CITY OF ST. HELENS PLANNING DEPARTMENT
STAFF REPORT
Variance V.2.24 & V.3.24

DATE: March 4, 2024
TO: Planning Commission
FROM: Jacob A. Graichen, AICP, City Planner

ZONING: General Residential, R5
LOCATION: 475 N. 12th Street; Lots 22 and 23, Block 5, Railroad Addition to St. Helens
PROPOSAL: Variances to allow a zero-foot side yard (setback) to allow two duplexes (one on each lot) to be attached at the property line

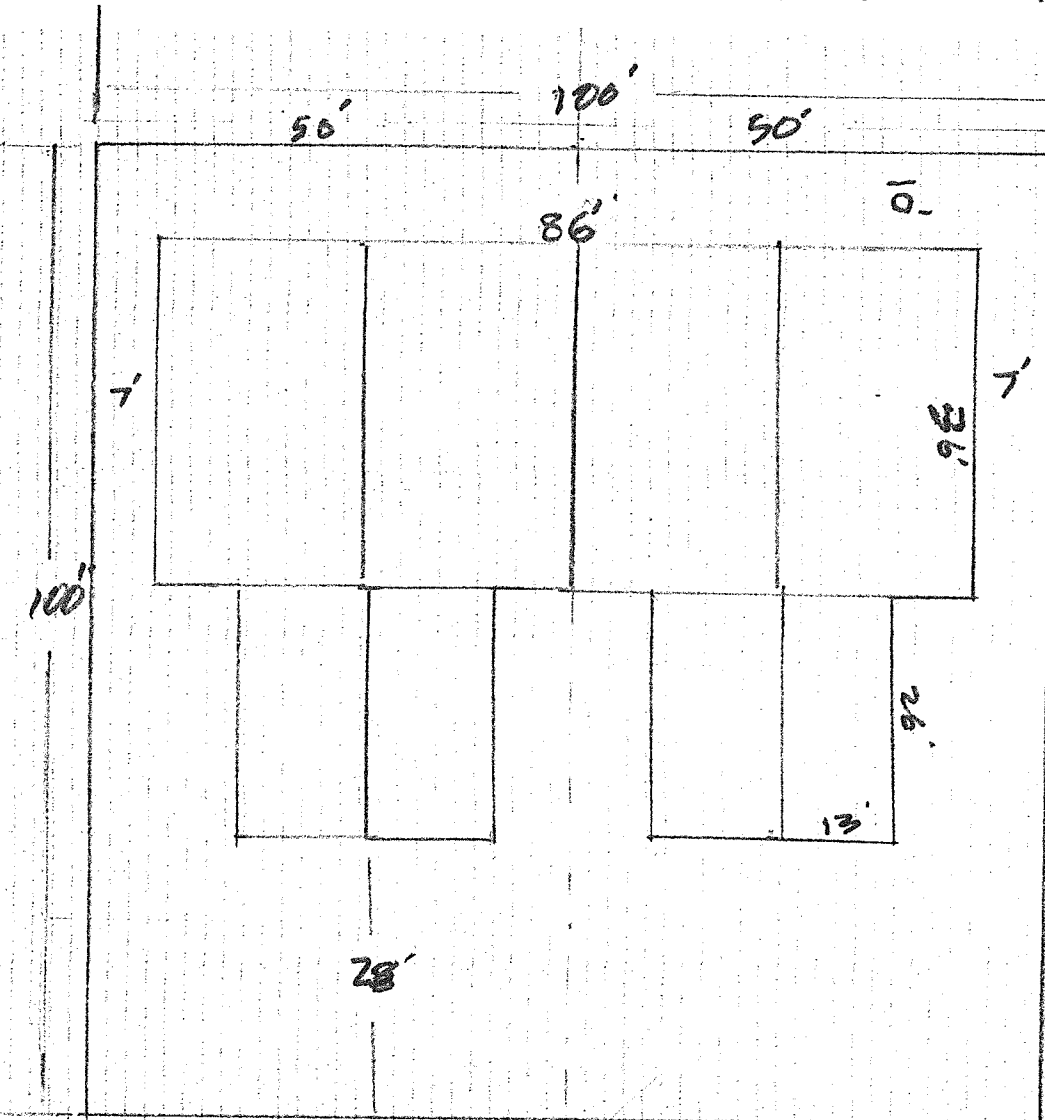
- See applicant's narrative.
- Staff comment(s): The Commission could require that the side yard (setback) on the non-attached side of each duplex to be 7' as the applicant's site plan shows as a value between 5' for duplexes and 10' for multidwelling development. Basis could be to offset the lesser air light and space at the shared wall on the lot line. This included in the staff recommended conditions.

Per the site plan for this proposal, the outer side yards (setbacks) are proposed to be 7-foot each, for a total of 14 feet. It could potentially have only 10' if the Variances were allowed without additional restrictions.

The Commission should consider if the Variances be granted specific to the plan provided and with a minimum 7' yard (setback). This included in the staff recommended conditions.

1. This Variance approval is valid for a limited time pursuant to SHMC 17.108.040.
2. These Variances shall apply to the specific proposal presented in the application. The Variances shall not apply to different plans, except minimum variation to ensure compliance with condition 3 and/or to meet any other requirement.
3. The minimum side yard (setback) for the non-attached sides shall be seven feet.
4. Owner/applicant and their successors are still responsible to comply with the City Development Code (SHMC Title 17), except for the Variance(s) granted herein.
